BEFORE THE ILLINOIS POLLUTION CONTROL BOARD

PCB Case No. 2023-049

CATHOLIC BISHOP OF CHICAGO'S MOTION TO DISMISS

Subject: Review of Second Draft Denial Response | IEPA Log # 2018-090 - Des Plaines Landfill

**DES PLAINES (SEXTON) LANDFILL
LEACHATE LEVEL AND
SHALLOW GROUNDWATER ELEVATIONS
SEPTEMBER 2017**

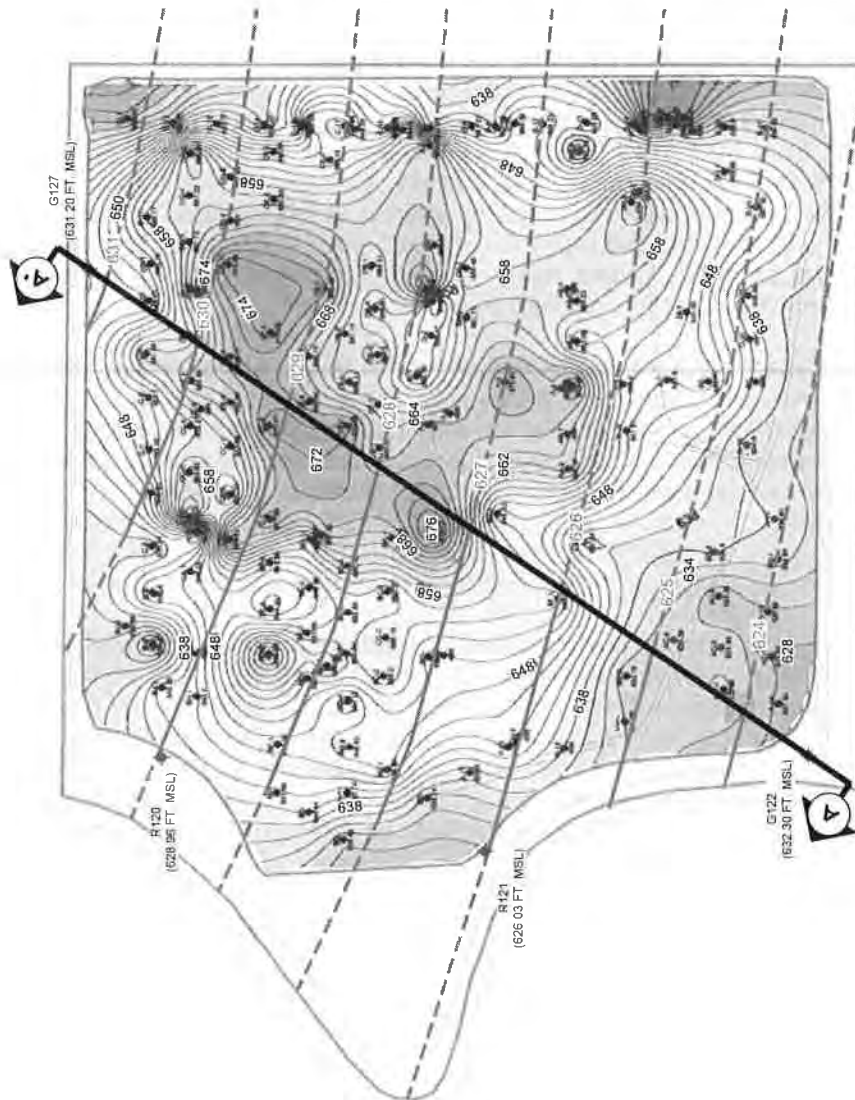
APTIM has obtained information regarding the measured leachate level elevations and measured shallow groundwater elevations from the IEPA via the Freedom of Information Act (FOIA) process. Measurements of the leachate levels within the Sexton Landfill were completed most-recently in September 2017. In order to accurately depict the conditions at the Sexton Landfill, measurements of the shallow groundwater unit from the third quarter of 2017 were utilized to evaluate the difference in elevation. As shown in the attached figures, leachate potentiometric levels are significantly above the groundwater table over the majority of the landfill's footprint.

Despite efforts to remove leachate from the landfill, leachate levels are approximately forty-three feet (43') higher than the groundwater table near its center. Near the approximate waste boundary, the leachate levels range between approximately five (5) and twenty (20) feet above the groundwater table. The most significant difference in elevation between the leachate levels and the shallow groundwater unit lies between G127 and the closest leachate extraction point (not readily identifiable). The high leachate levels indicate that storm water is likely penetrating the existing landfill cap. This mounding of leachate indicates radial flow away from the center of landfill. As the IEPA is aware, the Sexton Landfill is an Illinois Administrative Code 807 facility, and, as such, does not have a composite liner.

Based on the high leachate levels above the groundwater table within the landfill, APTIM continues to be concerned that the landfill final cover is not effective in minimizing storm water from infiltrating the cap. Due to the fact that proposed compost facility intends to use significant volumes of water to condition compost piles, locating a compost facility on top of this landfill will likely increase the leachate levels within the landfill. The mounding of leachate demonstrated in the attached figures, and resulting radial flow away from the facility, indicate that the potential for groundwater contamination from this unlined landfill is significant around the entirety of the landfill, and will likely be exacerbated by the addition of a compost facility.
